UNITED STATES PATENT AND TRADEMARK OFFICE

10/689,092

Lung-Po Tsai

Office Action Summary

5,403,163

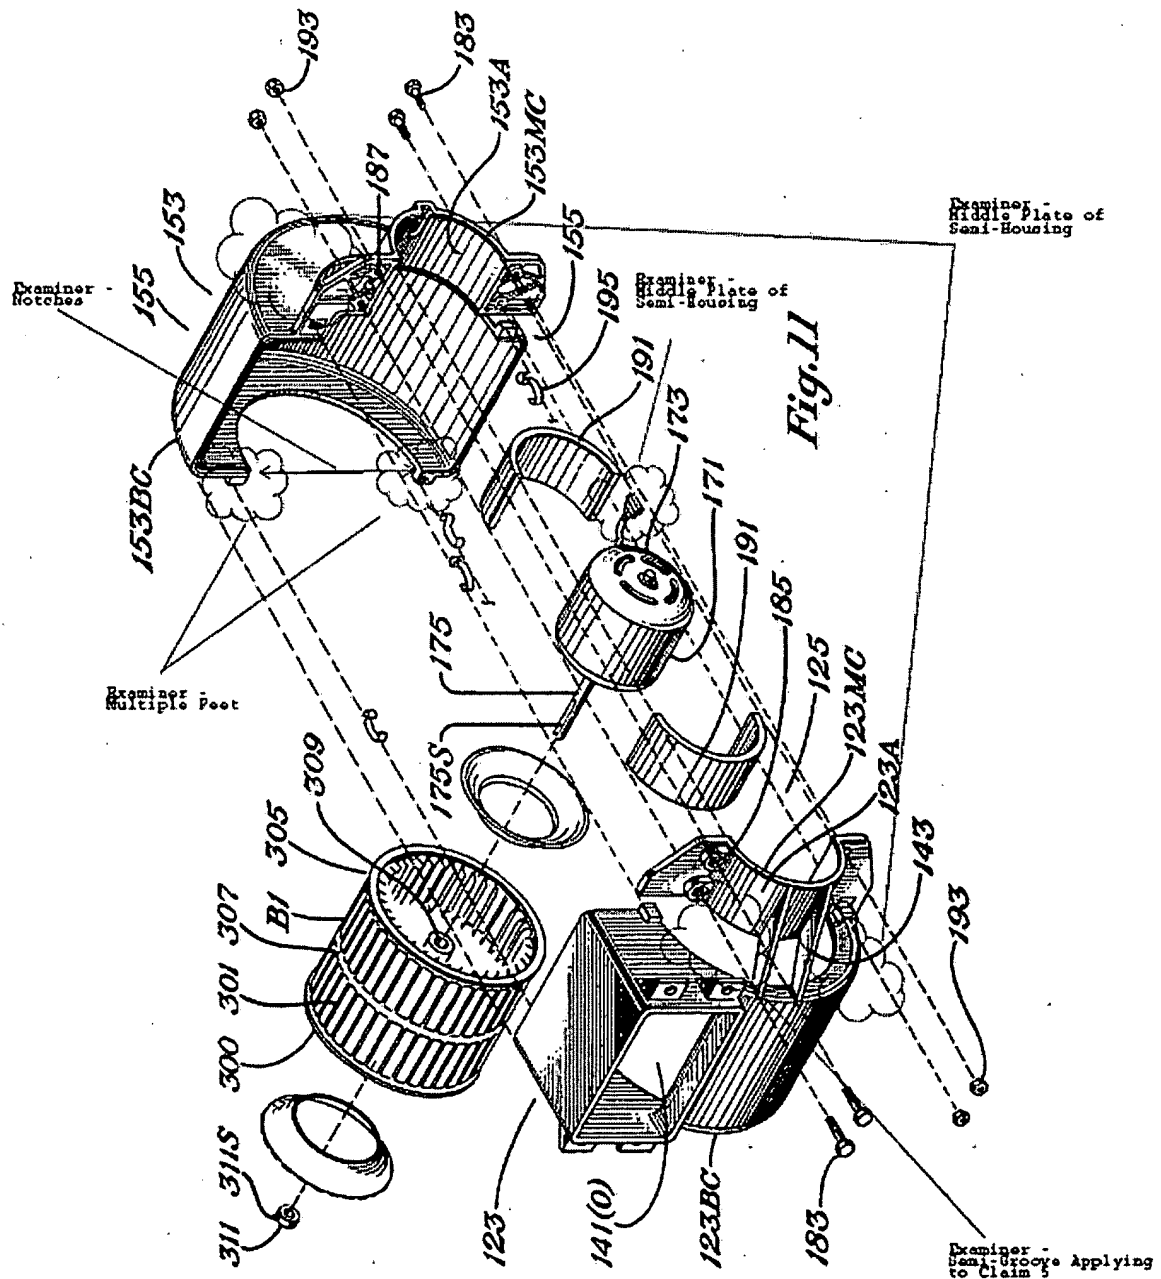
5. Claims 1, 2, and 5 are rejected under 35 U.S.C. 103(a) as being unpatentable over Murphy (US Patent No. 5,403,163) in view of Bradbury et al. et al. (US Patent No. 6,129,528) and Kenny et al. (US Patent No. 3,322,331) . With regards to claim 1 Murphy '163 teaches a housing being composed of two symmetrical semi-housings (Murphy – Figure 11 articles 123 and 153), wherein each semi-housing has multiple feet formed at a lower side thereof (Murphy –

Figure 11 articles 123 and 153), multiple notches respectively defined between the feet (Murphy – Figure 11 articles 123 and 153), an upper plate formed at an upper portion of said semi-housings (Murphy – Figure 11 articles 123MC and 153MC). Further Murphy '163 teaches that top of the intermediate surface of articles 123 and 153 (symmetrical semi-housings), joined to the top portions shown as 123A and 153A by article 143, serve as middle plates formed at a middle portions of said semi-housings (Murphy – Figure 11 articles 123 and 153). Murphy '163 teaches an air impeller mounted between the bottom plate and the middle plate of the semi-housings (Murphy – Figure 11 article B1), and a motor mounted between the middle plate and the upper plate of the semi-housings (Murphy – Figure 11 articles 173), and having an output axle extending downwards for driving the air impeller (Murphy – Figure 11 article 175). With regards to claim 2 of the claimed invention, the semi-housings taught by articles 123 and 153 by Murphy '163 in Figure 11 are cylindrical. With regards to claim 5 of the claimed invention, the area in between articles 153 and 153A, and 123 and 123A, and bridged by article 143 form matching semi-grooves transversely defined at an outer periphery. Figure 11 of Murphy '163 is included in this document for reference on the following page.

Murphy '163 does not teach that the top and bottom plates of the symmetrical semi-housings have multiple air inlets or multiple air outlets defined through a surface of the said plates, rather there is a single void or gap in each instance. Further Murphy '163 does not teach a circuit board installed in the housing and electrically connected with the motor although there is a means for making an electrical connection to the motor.
